HALEWOOD LEISURE CENTRE

RESPONSE TO COMMENTS

Presented to KMBC | September 2025

SITE ACCESS & VISIBILITY

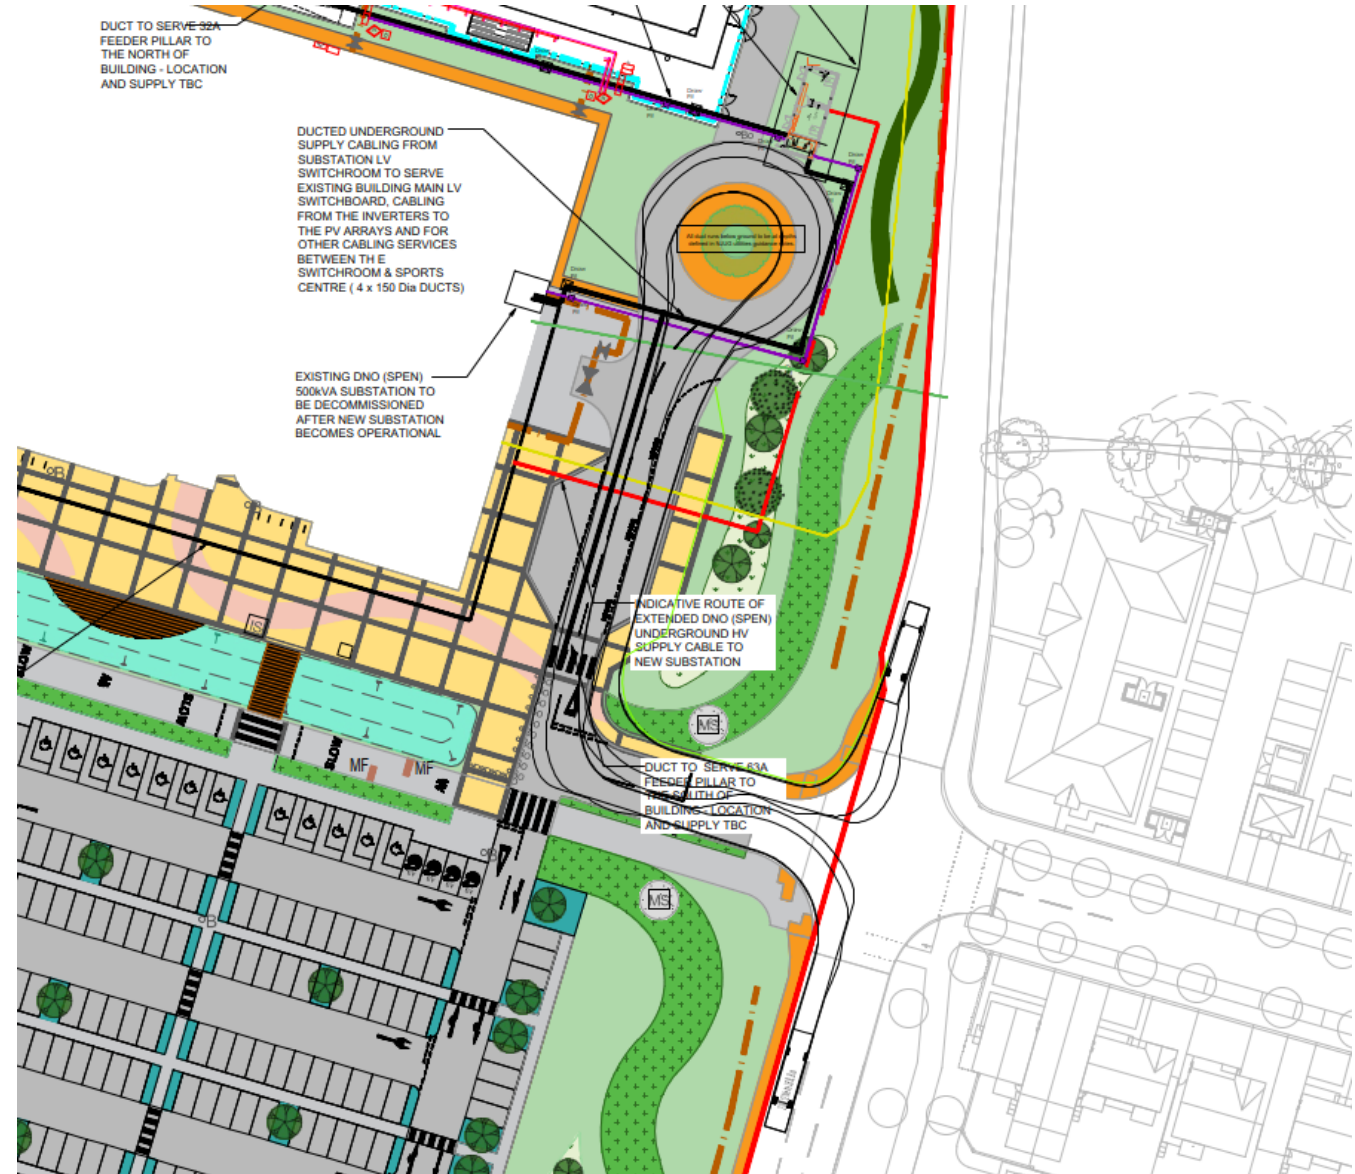
- The submitted swept path drawing for a 12m coach (VT03) demonstrated the largest vehicle likely to use the site access. It illustrates encroachment across the opposing lane within the access throat during both entry and exit, and an internal three-point turn to reverse direction at the northern end of the site.

- Re-work the access geometry to keep a 12m coach within lane on entry/exit without relying on opposing-lane encroachment where possible.
